Medworth Energy from Waste Combined Heat and Power Facility Permit Application (EPR/HP3441QA/A001) – Response to Request for Further Information

1. Purpose of this note

The figure overleaf displays the areas of the site defined as essential infrastructure in purple (replicates Figure 6.1 in the FRA).

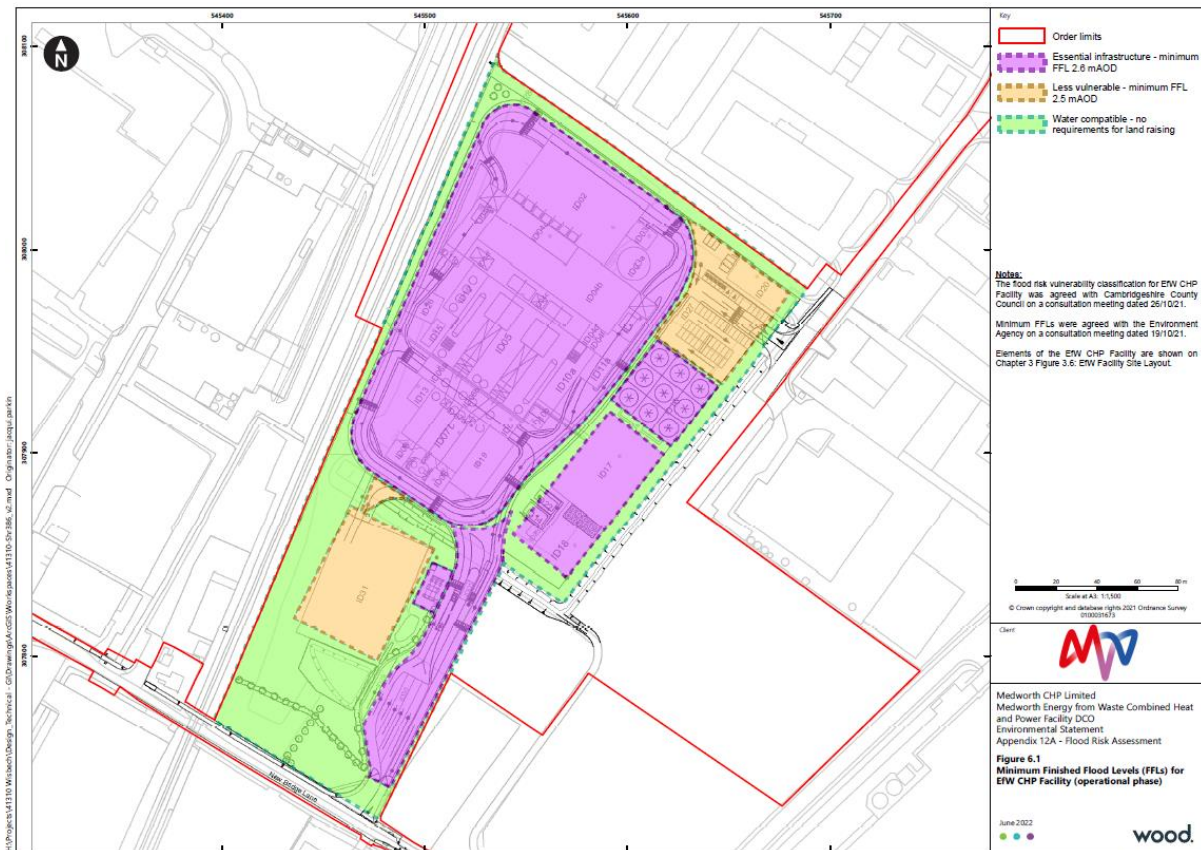
a) Update table 3.4 of “Supplementary Technical Information Report for Medworth CHP Ltd” to include measures that would prevent pollution in the event of a flood.

Response: An assessment of the potential risks associated with flooding, including the measures in place to reduce risk, is included in the “General site issues” section of Table 3-4 in the row labelled “Site flooding resulting in contaminated waste and other materials entering surface water drains”. However, the measures that would prevent pollution in the event of a flood are described below for convenience.

Whilst areas of the site are designated Flood Zone 3, the Flood Risk Assessment (FRA) contained within Appendix A12 of the permit application (“MVV Volume 6.4 ES Chapter 12 Hydrology Appendix 12A FRA.pdf”) identifies that the site of the EfW CHP Facility would remain dry during the design flood event (0.5% AEP plus climate change overtopping event) and the 0.1% AEP plus climate change overtopping event.

The only scenario under which there is a residual risk of flooding at the site of the EfW CHP Facility is the 0.1% AEP plus climate change tidal breach event.

The principal control measure incorporated into the design of the EfW CHP Facility to reduce the risks of flooding during this scenario is to designate and design areas containing essential infrastructure with finished floor levels (FFL) above the peak floodplain water level at the site during the 0.1% AEP plus climate change tidal breach event.

Areas of the site identified as essential infrastructure are the only areas where potentially polluting substances (PPS) may be stored. Ensuring PPS are stored in areas where the FFL is above the peak floodplain water level at the site during the 0.1% AEP plus climate change tidal breach scenario is considered to represent an effective control measure that will ensure a low likelihood of pollution during a flooding event. This measure will also ensure that the essential infrastructure elements remain operational and safe in times of flood whilst waste and other raw materials are on site.
